Appendix H

Traffic assessment issues analysis and response

To: Thomas Frankham
From: Ody Murlianto
Subject: **Hunter Valley Operations Continuation Project EIS Review**
Our ref: PS204979-SYD-PAM-MEM-002
Date: **13 October 2023**

TITLE: ACCESS DRIVEWAY TO GLIDING CLUB
STRATEGIC DESIGN
PLAN
SHEET 01

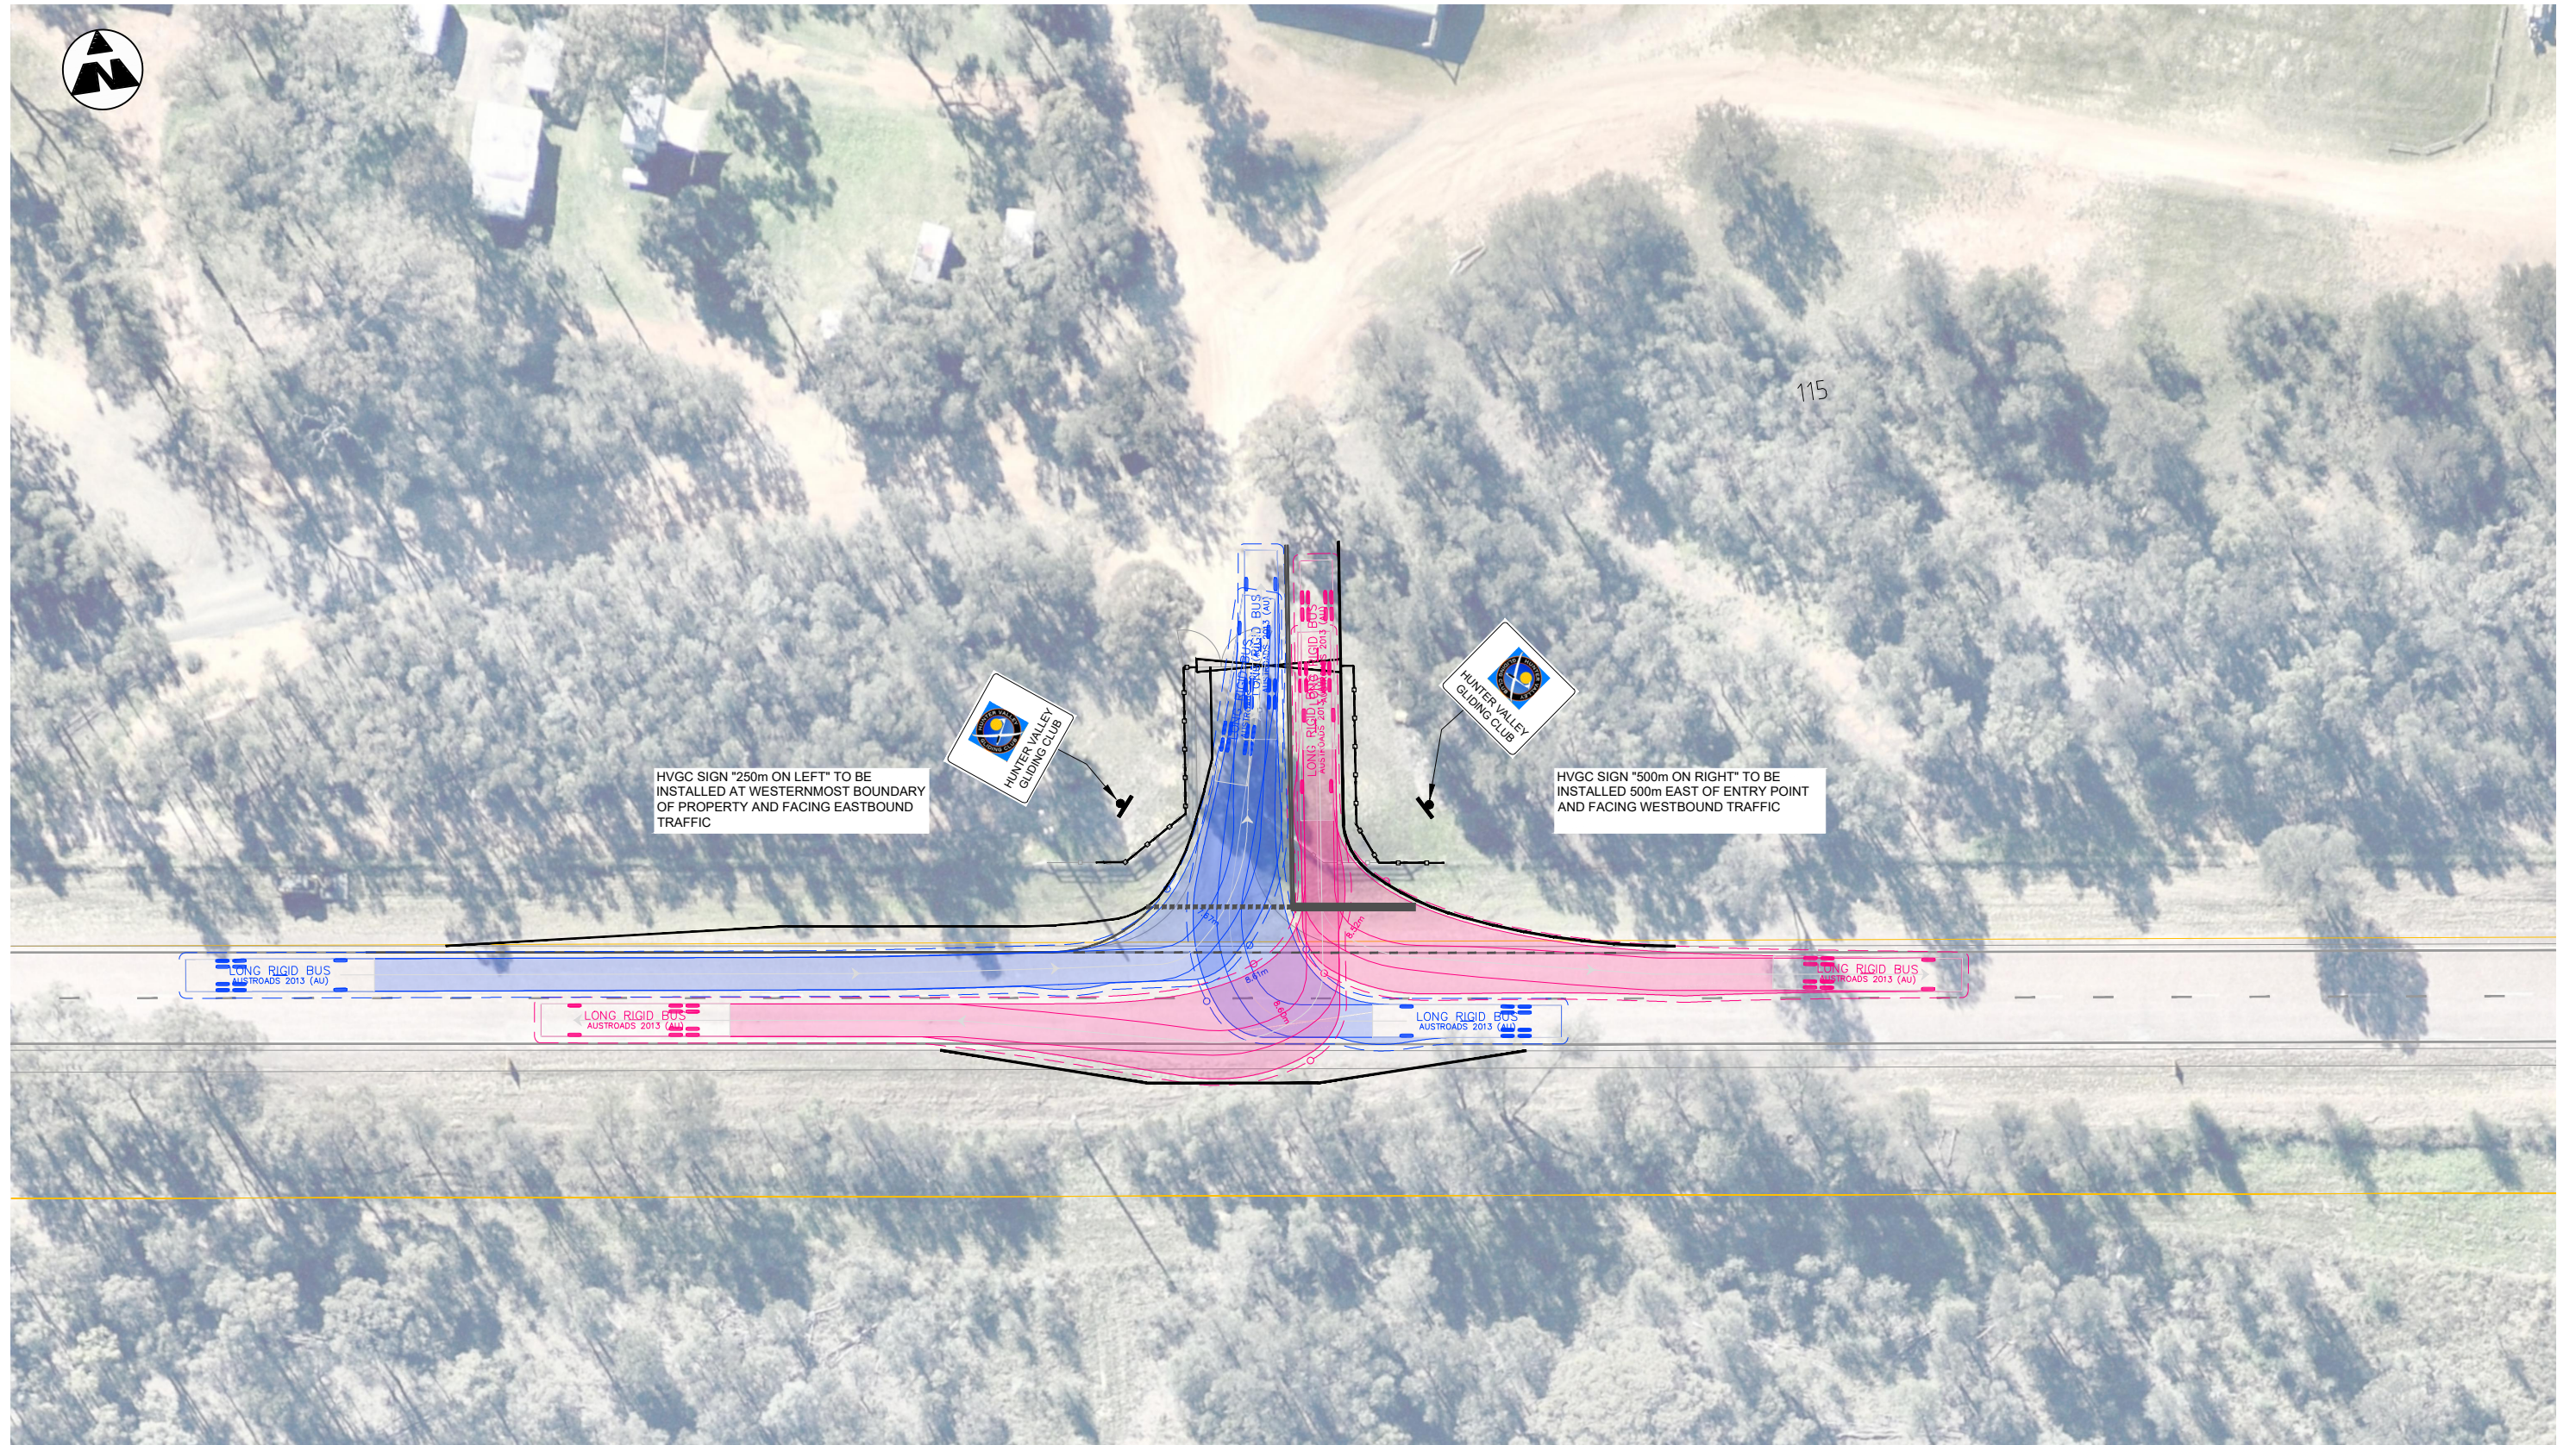
The driveway to the HVGC facilities and Warkworth Airfield is relatively narrow and visually unobtrusive. It requires vehicles to all but stop in the travel lane before turning. This is especially so for club members' vehicles towing glider trailers which are typically nine metres in length.

1. PROPERTY ACCESS FOR THE HUNTER VALLEY GLIDING CLUB HAS BEEN DESIGNED WITH LOCALISED WIDENING TO ALLOW SUFFICIENT SPACE FOR DESIGN VEHICLES TO UNDERTAKE NON-CONFLICTING CONCURRENT INBOUND AND OUTBOUND MOVEMENTS.
2. HUNTER VALLEY GLIDING CLUB SIGNS ARE PROPOSED AT THE PROPERTY ACCESS AND RESPECTIVE EASTBOUND AND WESTBOUND APPROACHES TO PROVIDE VISUAL CUES FOR DRIVERS TRAVELLING ON COMLEROI ROAD.
3. THIS SKETCH HAS BEEN PREPARED ON AN AERIAL OBTAINED FROM NEARMAP DATED MAY 2022.
4. LOCATION OF PROPERTY BOUNDARIES HAVE BEEN OBTAINED FROM NSW GOVERNMENT'S SPATIAL COLLABORATION PORTAL WEBSITE.
